RECALL BULLETIN:
80724

PRODUCT(S) AFFECTED:
Terra, Fiesta,
With Unit Serial
Numbers Listed
in this Bulletin

SUBJECT:
Inspection/
Correction of
Wiring Harness
Clearance

ISSUE DATE:
August 2008

Figure 6

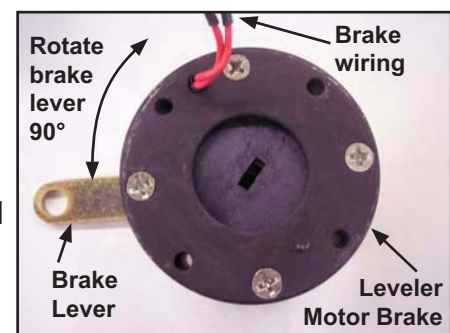
The leveling motor brake will need to be rotated to provide adequate clearance in the wheel well for the brake release lever. Follow Steps 29-37 to perform this procedure.

29. Cut the metal clamp securing the rubber boot over the leveler motor brake on the uninstalled jack; remove the boot and retain for reinstallation. Discard the clamp.
30. Note the current orientation of the brake lever to the motor.
31. Remove the 4 screws and washers fastening the leveler motor brake to the motor. Retain hardware for reassembly.
32. Release the brake lever to disengage the brake and allow it to be rotated.
33. Rotate the leveler brake 1/4 turn (90°). See Figure 6.

Note: After the leveler brake is rotated, it will be oriented toward the front of the motor home once the leveling jack is installed.

34. Verify the motor brake wire connections are secure and exit the slot in the spacer without becoming pinched. Reinstall the motor brake to the motor using the original fastening hardware. Torque fasteners to 14-16 in-lbs. Do not over-torque as screws may strip.
35. Return the brake lever to the engaged position.
36. Position the rubber brake boot, removed in Step 29, over the motor brake and motor housing, making sure the motor brake fits inside the “duck bill” shaped portion of the boot.
37. Slide a new metal clamp (Part # 559083) over the boot, approximately 1/4” from the top of the boot. Verify the clamp is not positioned over the motor wires or grommet. Crimp the metal clamp with an end crimping tool to secure the brake boot.

Figure 7

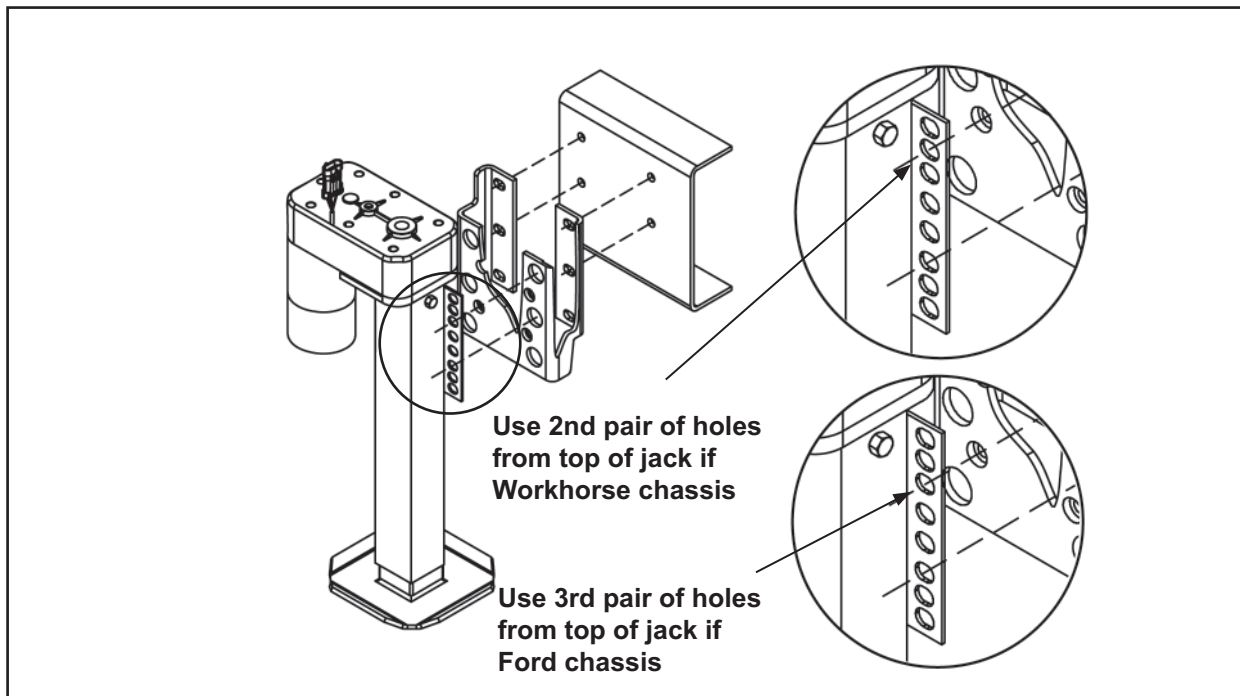
Follow Steps 38-42 to relocate the leveling jack forward of its original mounting location in order to provide clearance for the wiring harness.

38. Make a new drilling template in order to re-locate the front roadside jack forward by 2”, using the original leveling jack mounting bracket holes in the chassis rail as a guide.
- Note: If an existing slot in the chassis rail is located in the area where the jack is to be relocated, it may be used as one of the four holes for mounting the jack bracket.
39. Position the drilling template, created according to Step 38, against the chassis rail. Verify drilling locations are square and are at the same level as the original mounting holes. Drill 1/8” diameter pilot holes through the chassis rail at each drilling location marked on the template.
40. Drill 1/2” holes for bolts, on center with the pilot holes drilled in Step 39.

41. After completing all drilling operations, reposition brake and fuel lines in their original location and reattach them to chassis mounting brackets.
42. Install the leveling jack mounting bracket in its new location (2" forward of the original location) using the original attachment hardware, then fasten the jack to the mounting bracket. Torque bolts to 65 ft-lbs. Verify all front roadside leveler components have adequate clearance around other components; adjust as necessary.

- If utilizing an existing slot in the chassis rail as one of the four holes for the new jack mounting bracket location, use a washer of sufficient size to keep the bolt head stationary.
- Position the leveling jack motor housing facing the front of the motor home.
- Mount the jack in the 2nd pair of holes from the top of the jack leg if a Workhorse chassis, or the 3rd pair of holes from the top if a Ford chassis. See Figure 7.
